City of Irvine
Parks Master Plan
FINAL | JULY 2015

ADA Assessment of Play Areas in Irvine Parks

TECHNICAL SUPPLEMENT

Brywood Park: Ages 2 to 5 Play Equipment Area

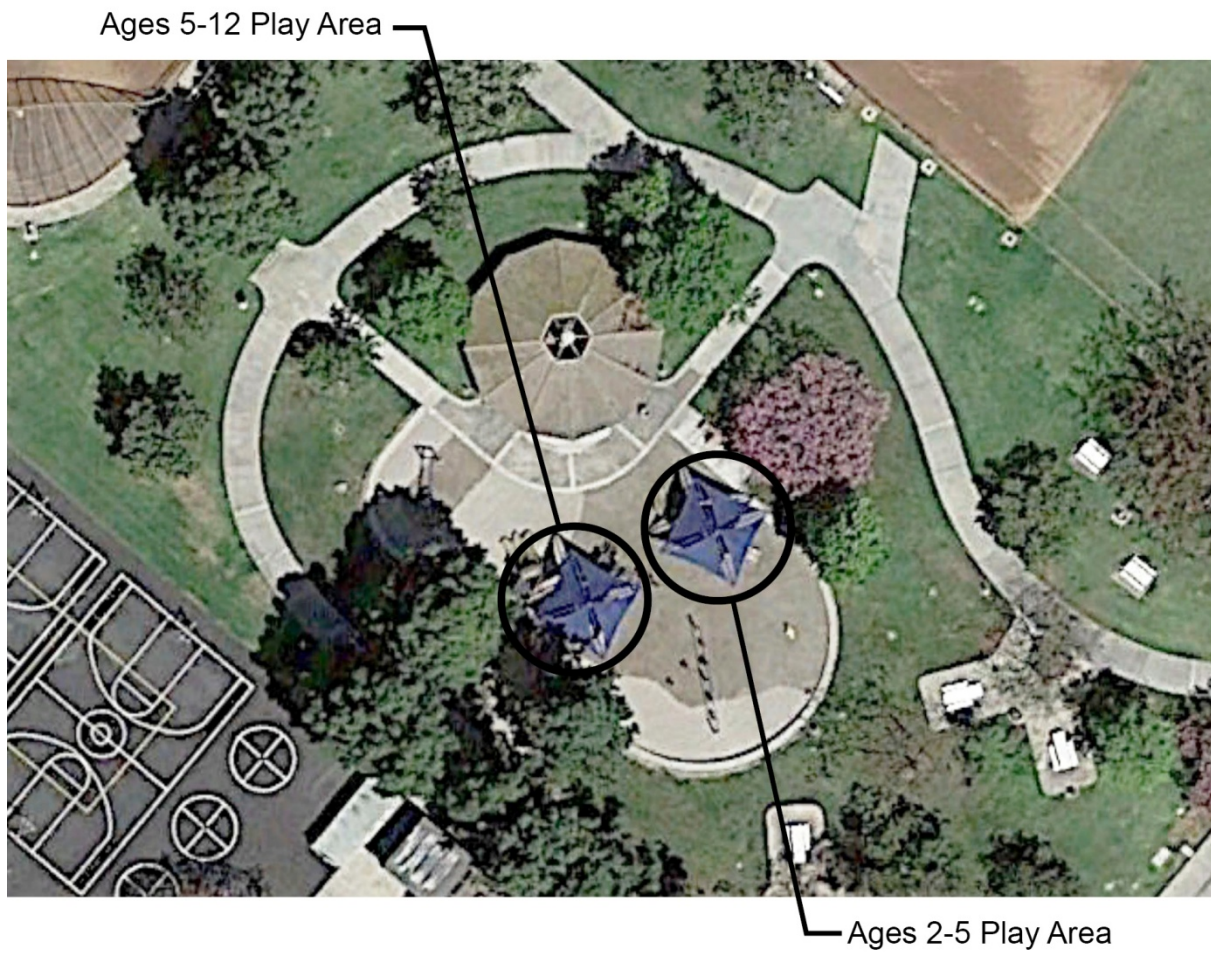
Action	Action Note	Planning Cost Estimate	Relevant Code
Install or modify transfer system	The 30 by 48 inch ground space adjacent to transfer platform has a slope of up to 2.2 percent (2.0 percent maximum permitted).	\$400	CBC 11B-1008.3.1.3 ADA 1008.3.1.3
Install tread striping	Striping is not provided on stairs connecting play components.	\$200	CBC 11B-210.1 CBC 11B-504.4.1
Provide play components	Knee space at play table is 20-3/4 inches high and 23 inches wide between benches (24 inches minimum height and 30 inches minimum width). The table is not positioned to allow for a parallel approach. Table is 11 inches behind front of benches.	\$5,000	CBC 11B-1008.4.3 ADA 1008.4.3
Improve or evaluate play area surface	Further evaluation of fall attenuation surface is recommended.	\$0	CBC 11B-1008.2.6.1 ADA 1008.2.6.1 ADA 1008.2.6.2
Total		\$5,600

Ages 2-5 Play Area

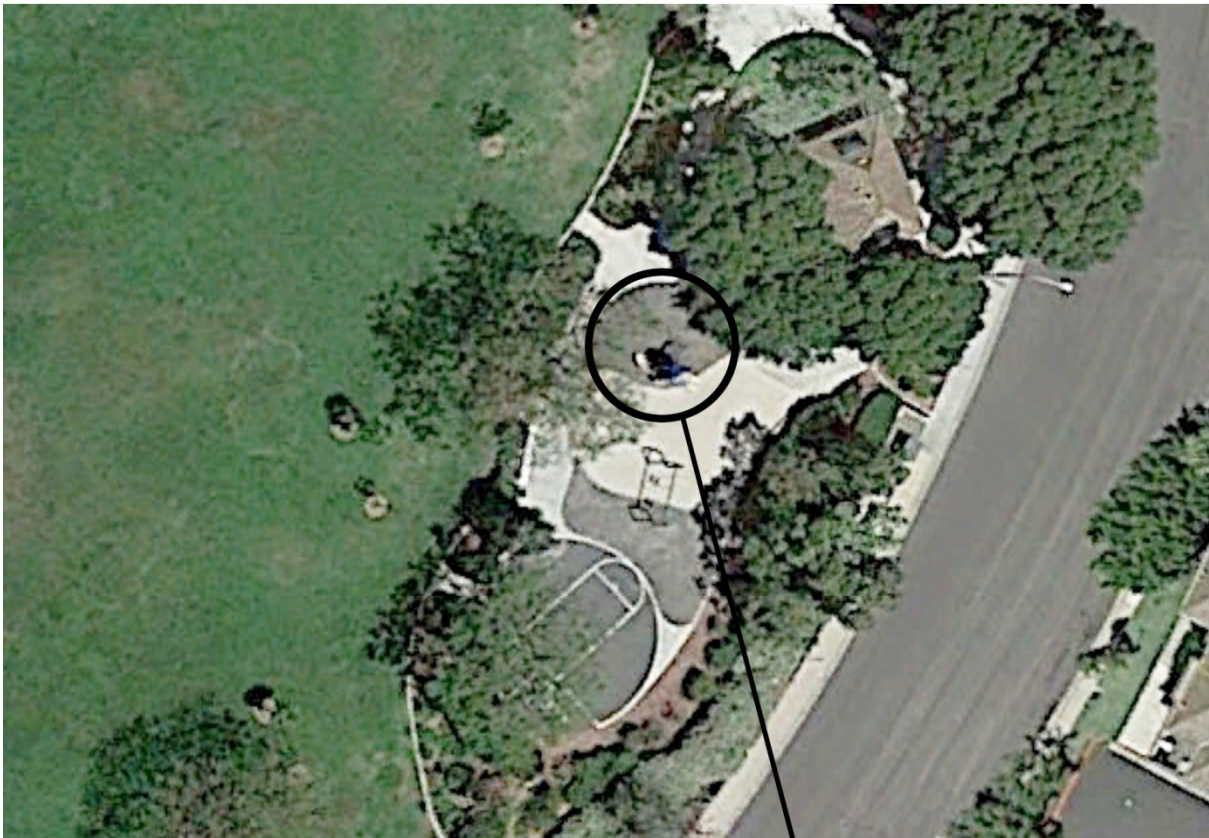
Action	Action Note	Planning Cost Estimate	Relevant Code
Provide an accessible path of travel	An accessible route is not provided to alphabet panel due to 12 inches wide poured in place surface and sand for six linear feet.	\$180	CBC 11B-206.2.17.1 CBC 11B-1008.2 ADA 206.2.17.1 ADA 1008.2
Improve or evaluate play area surface	Further evaluation of fall attenuation surface is recommended. Top layer of surface worn near swings.	\$0	CBC 11B-1008.2.6.1 ADA 1008.2.6.1 ADA 1008.2.6.2
Install tread striping	Striping is not provided on stairs connecting play components.	\$200	CBC 11B-210.1 CBC 11B-504.4.1
Modify play component	A 30 by 48 inch minimum clear space with a slope of 2.0 percent maximum is not provided at the alphabet panel due to sand surface.	\$400	CBC 11B-1008.4.2 ADA 1008.4.2
Total		\$780

Ages 5-12 Play Area

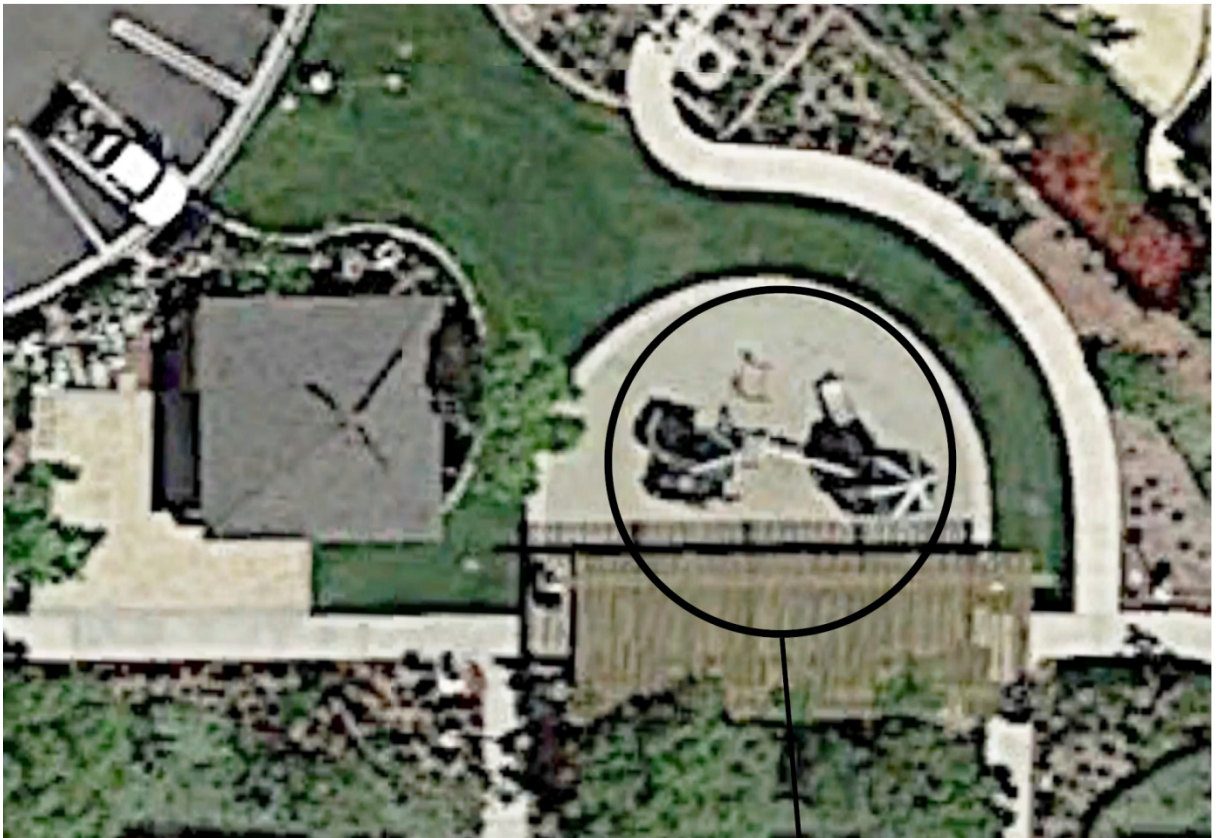
Action	Action Note	Planning Cost Estimate	Relevant Code
Improve or evaluate play area surface	Further evaluation of fall attenuation surface is recommended. Deteriorated top surface and cracks observed in poured in place surface.	\$0	CBC 11B-1008.2.6.1 ADA 1008.2.6.1 ADA 1008.2.6.2
Install or modify transfer system	Transfer platform surface heights are 18-1/2 and 20-7/8 inches (11 inches minimum to 18 inches maximum required) above the accessible surfacing. Adjacent decks are 14 or 15-1/2 inches above ground surface but lack the required vertical supports.	\$5,000	CBC 11B-1008.3.1.2 ADA 1008.3.1.2
Install tread striping	Striping is not provided on stairs connecting play components.	\$200	CBC 11B-210.1 CBC 11B-504.4.1
Modify play component	The ground level spin panel is centered at 45 inches above play surface (advisory: 44 inches maximum for ages 5 to 12).	\$125	CBC 11B-308.1 ADA 308.1
Provide an accessible path of travel	Vertical clearance of accessible route is 67 inches at ring trek (80 inches minimum required).	\$125	CBC 11B-1008.2

College Park: Ages 2 to 5 Play Equipment Area

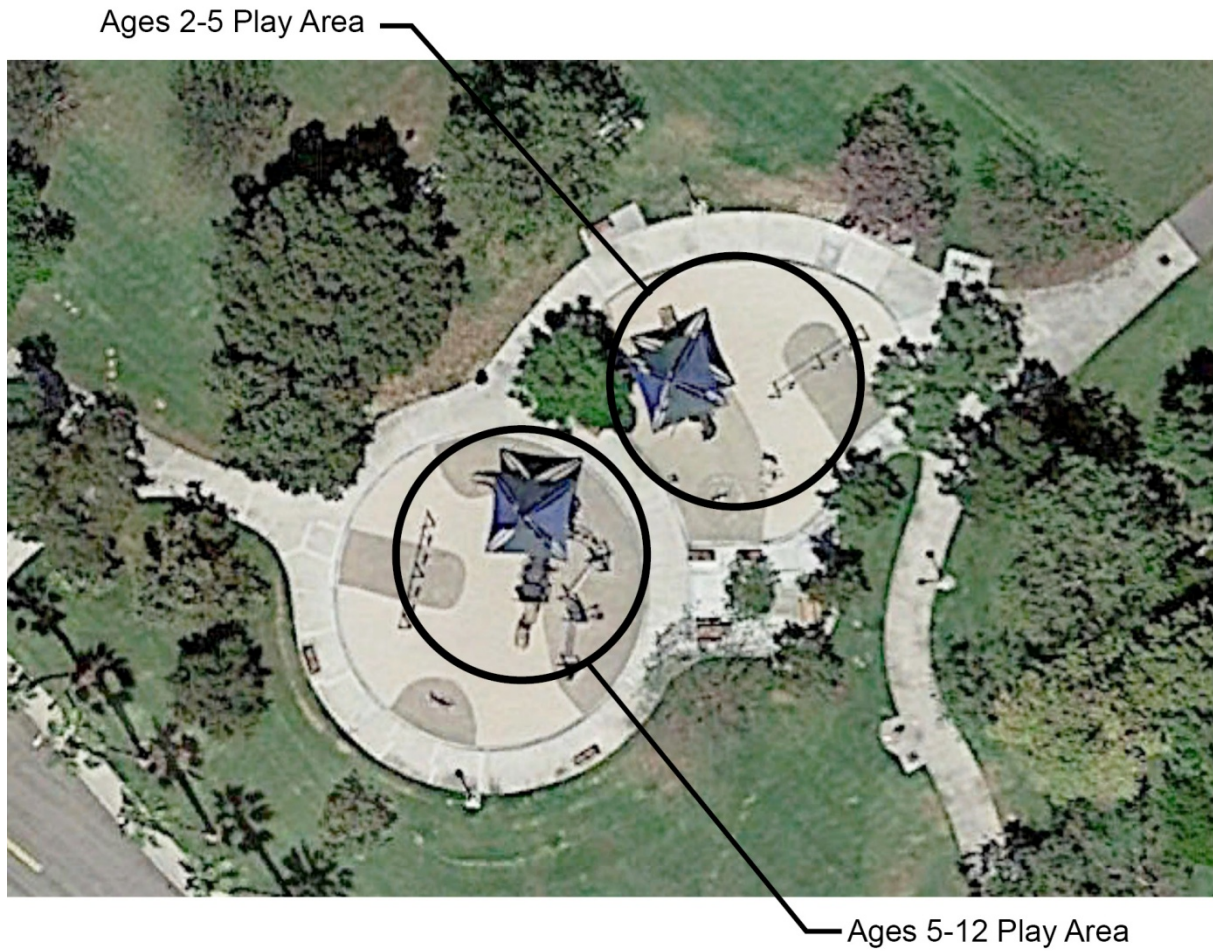
Action	Action Note	Planning Cost Estimate	Relevant Code
Improve or evaluate play area surface	Further evaluation of fall attenuation surface is recommended. There is up to 1/2 inch changes in level between poured in place surface and adjacent concrete. Cracks observed in top layer of accessible surface.	\$0	CBC 11B-1008.2.6.1 ADA 1008.2.6.1 ADA 1008.2.6.2
Modify play component	The 30 by 48 inch ground space adjacent to the fire truck spring toy has a slope of up to 2.7 percent (2.0 percent maximum allowed). The 30 by 48 inch ground space adjacent to the toddler swing with belt has a slope of up to 2.3 percent (2.0 percent maximum allowed). The 30 by 48 inch ground space at sand-play tables does not provide an accessible surface.	\$1,200	CBC 11B-1008.4.2 ADA 1008.4.2
Provide play components	Knee space at play table is 20-5/8 inches high (24 inches minimum height for tables not set up for parallel approach). The table is not positioned to allow for a parallel approach. Table is 7-5/8 inches behind front of benches.	\$5,000	CBC 11B-1008.4.3 ADA 1008.4.3

Colonel Bill Barber Park: Ages 2 to 5 Play Equipment Area

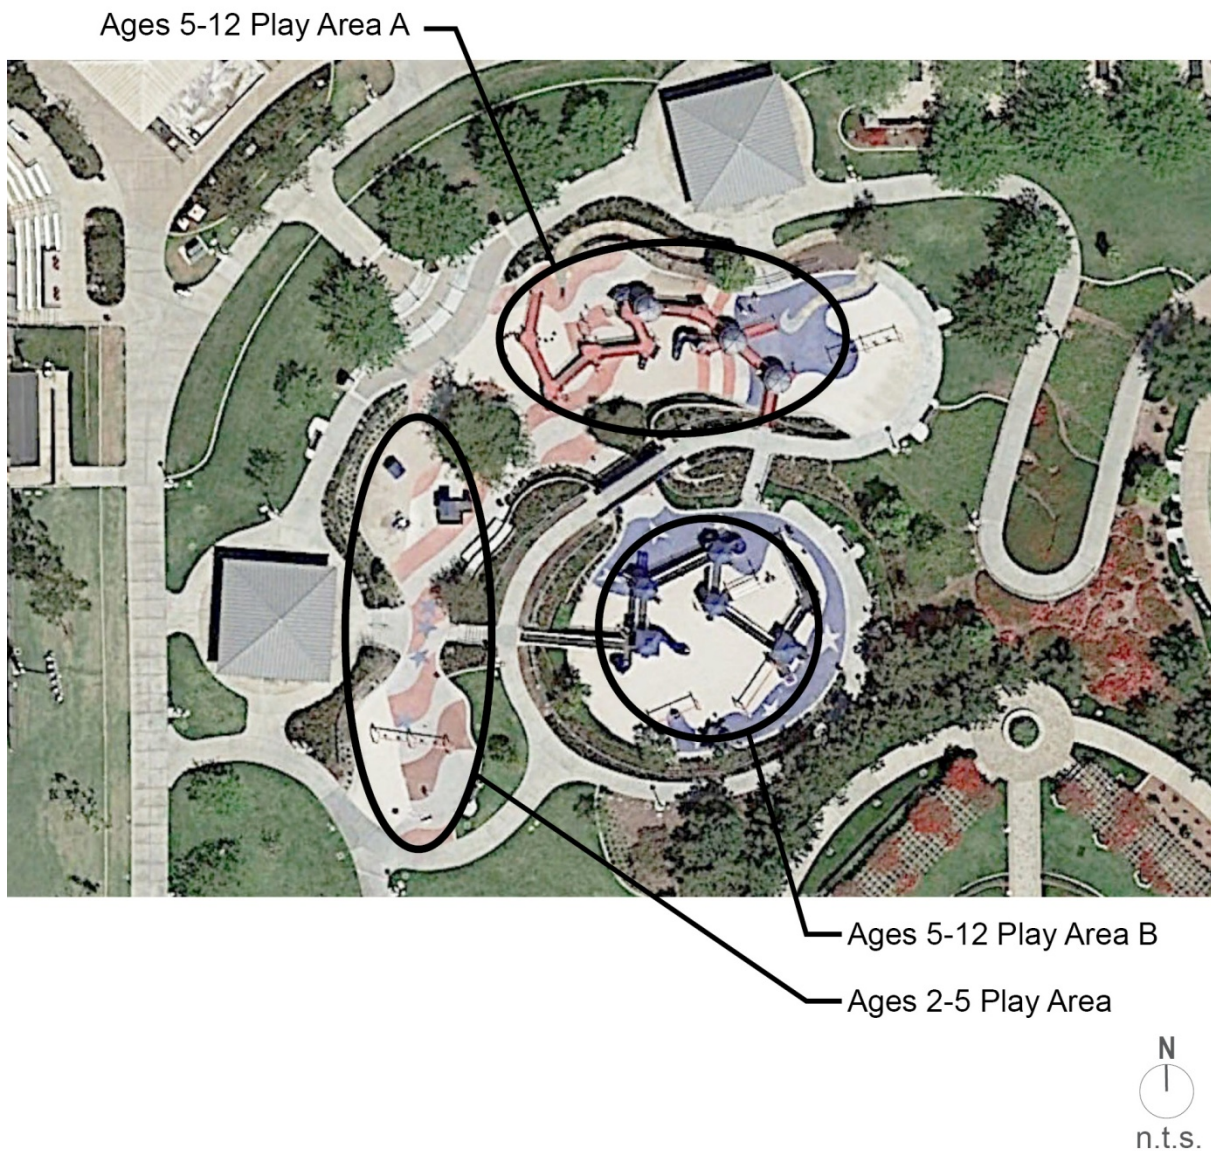
Action	Action Note	Planning Cost Estimate	Relevant Code
Provide an accessible path of travel	An accessible route is not provided from an accessible play area entry to the club house in the sand play area route is seven linear feet from poured in place surface.	\$210	CBC 11B-206.2.17.1 CBC 11B-1008.2 ADA 206.2.17.1 ADA 1008.2
Improve or evaluate play area surface	Further evaluation of fall attenuation surface is recommended.	\$0	CBC 11B-1008.2.6.1 ADA 1008.2.6.1 ADA 1008.2.6.2
Install tread striping	Striping is not provided on stairs connecting play components.	\$200	CBC 11B-210.1 CBC 11B-504.4.1
Install or modify transfer system	A transfer system is not provided onto the composite structure.	\$5,000	CBC 11B-1008.3 ADA 1008.3
Total		\$5,410

Comstock Park: Ages 2 to 5 Play Equipment Area

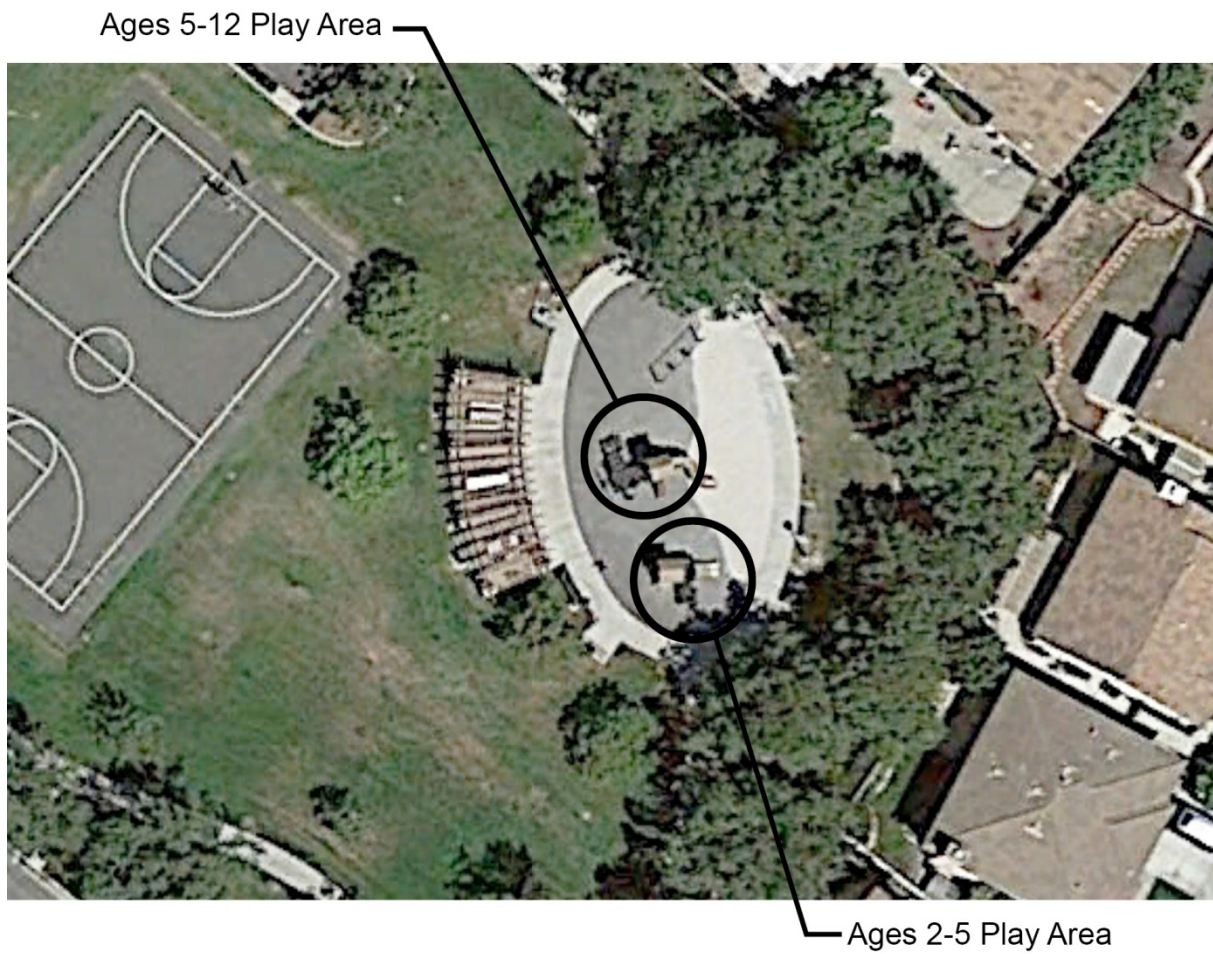
Action	Action Note	Planning Cost Estimate	Relevant Code
Improve or evaluate play area surface	Further evaluation of fall attenuation surface is recommended. Sand surface had migrated onto poured in place to a depth that would not be considered firm and stable. Ongoing maintenance required.	\$0	CBC 11B-1008.2.6.1 ADA 1008.2.6.1 ADA 1008.2.6.2
Install tread striping	Striping is not provided on stairs connecting play components.	\$200	CBC 11B-210.1 CBC 11B-504.4.1
Total		\$200

Ages 5-12 Play Area

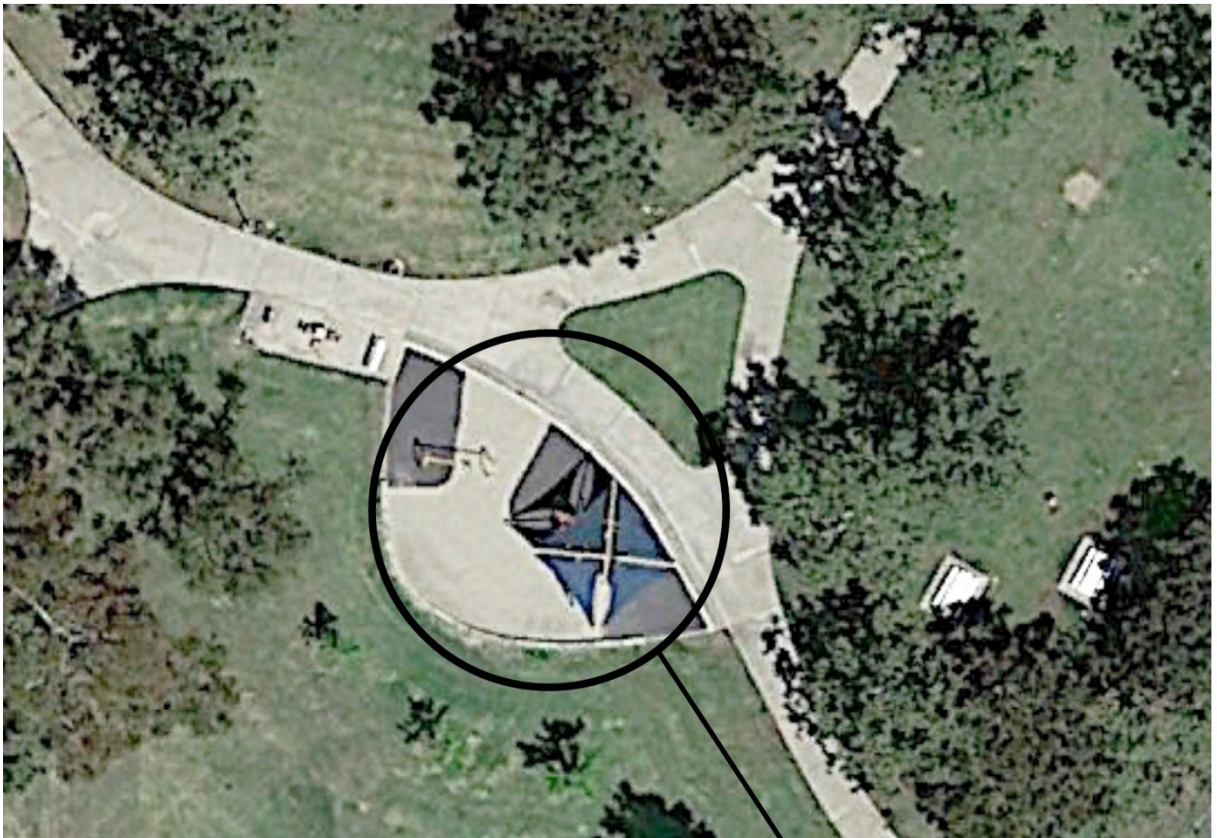
Action	Action Note	Planning Cost Estimate	Relevant Code
Improve or evaluate play area surface	Further evaluation of fall attenuation surface is recommended.	\$0	CBC 11B-1008.2.6.1 ADA 1008.2.6.1 ADA 1008.2.6.2
Provide an accessible path of travel	An accessible route is not provided to the fossil panel or the spin wheel.	\$400	CBC 11B-206.2.17.1 CBC 11B-1008.2 ADA 206.2.17.1 ADA 1008.2
Install or modify transfer system	The 30 by 48 inch ground space adjacent to transfer platform has a slope of up to 3.0 percent (2.0 percent maximum allowed).	\$400	CBC 11B-1008.3.1.3 ADA 1008.3.1.3
Install tread striping	Striping is not provided on stairs connecting play components.	\$200	CBC 11B-210.1 CBC 11B-504.4.1
Modify play component	A 30 by 48 inch minimum clear space with a slope of 2.0 percent maximum is not provided at the fossil panel or the spin wheel due to sand surface.	\$400	CBC 11B-1008.4.1 CBC 11B-1008.4.2 ADA 1008.4.1 ADA 1008.4.2

Provide play components	Knee space at play table is 20-3/4 inches high (24 inches minimum height required).	\$5,000	CBC 11B-1008.4.3 ADA 1008.4.3
Total		\$6,400

Cypress Park: Ages 2 to 5 Play Equipment Area

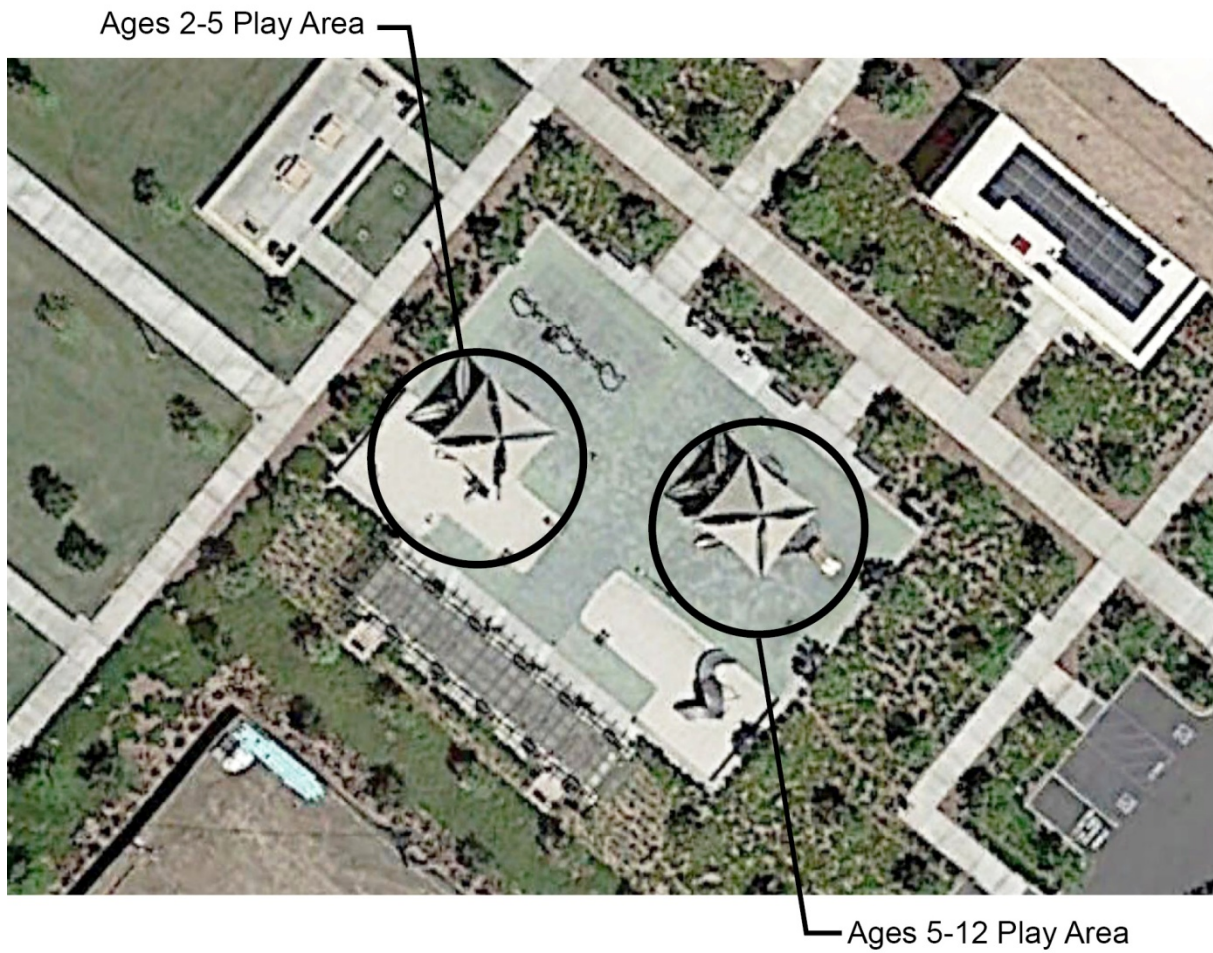
Action	Action Note	Planning Cost Estimate	Relevant Code
Install tread striping	Striping is not provided on stairs connecting play components.	\$200	CBC 11B-210.1 CBC 11B-504.4.1
Improve or evaluate play area surface	Further evaluation of fall attenuation surface is recommended.	\$0	CBC 11B-1008.2.6.1 ADA 1008.2.6.1 ADA 1008.2.6.2
Provide play components	Knee space at play table is 19 inches high (24 inches minimum height required). The table is not positioned to allow for a parallel approach. Table is 11 inches behind front of benches.	\$5,000	CBC 11B-1008.4.3 ADA 1008.4.3
Total		\$5,200
